**MONTGOMERY COUNTY PLANNING DEPARTMENT**  
**THE MARYLAND-NATIONAL CAPITAL PARK AND PLANNING COMMISSION**

**DATE:** September 3, 2010  
**TO:** Montgomery County Planning Board  
**VIA:** Rose Krasnow, Chief, Development Review Division *RK*  
**FROM:** Elsabett Tesfaye, Planner Coordinator (301) 495-1301 *ET*  
**SUBJECT:** **Development Plan Amendment No: 05-02:** Branch Banking and Trust Company. Request for revision of conditions of approval of G-540, approval of a new schematic plan and rezoning of lot 22 for consolidation with lots 7 and Lot 23 for a construction of a drive-through bank on Lots 7, 22, and 23 at 11107 Valleyview Drive, 2907 and 2909 University Boulevard, Kensington, Maryland.

Staff recommends Disapproval of DPA-05-2.

# SCHEMATIC DEVELOPMENT PLAN

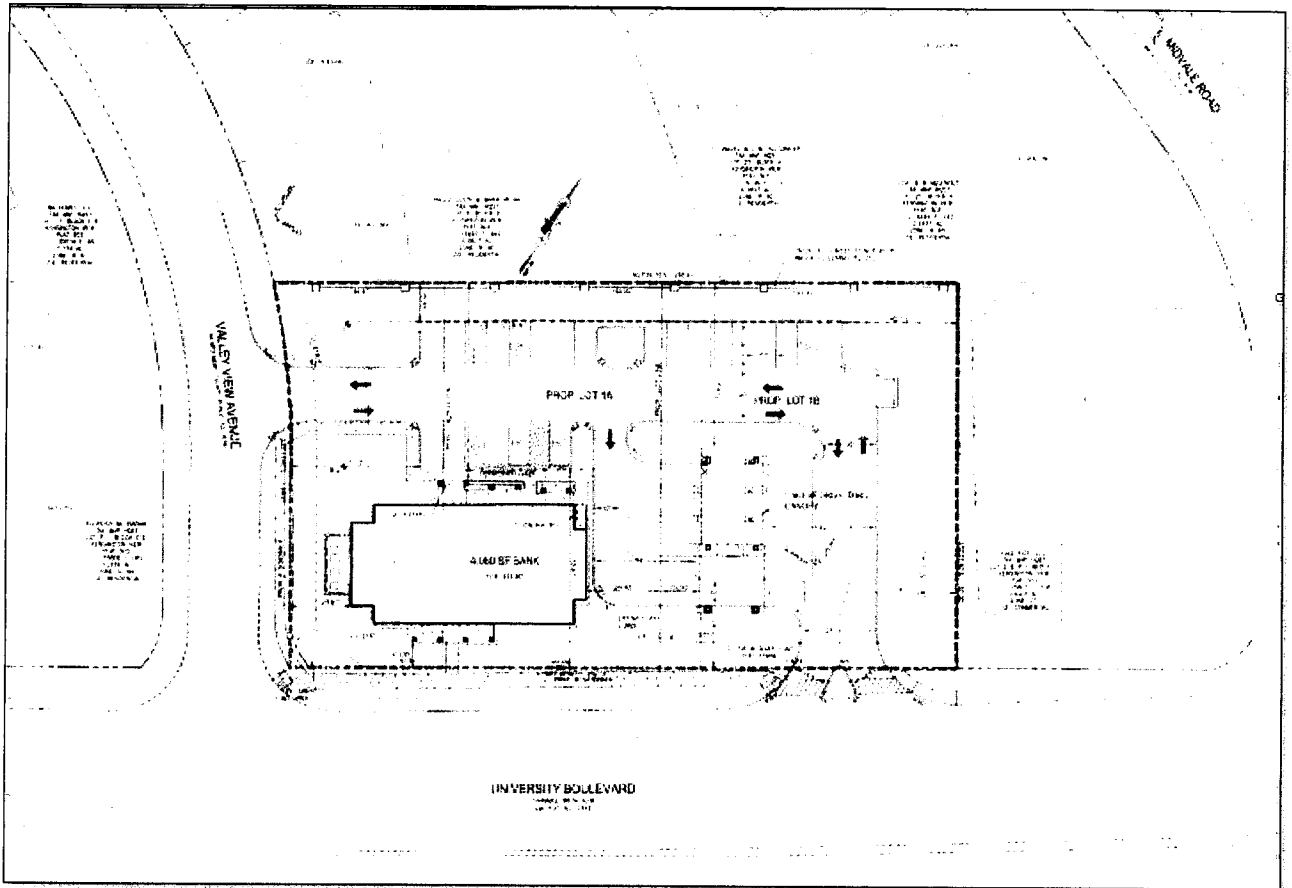
Upon discussion between the applicant and staff, the applicant has revised (received June 26, 2010) the SDP showing the existing 40Ft BRL (University Boulevard frontage) and 30 FT BRL (Valleyview frontage) on Lot 7.
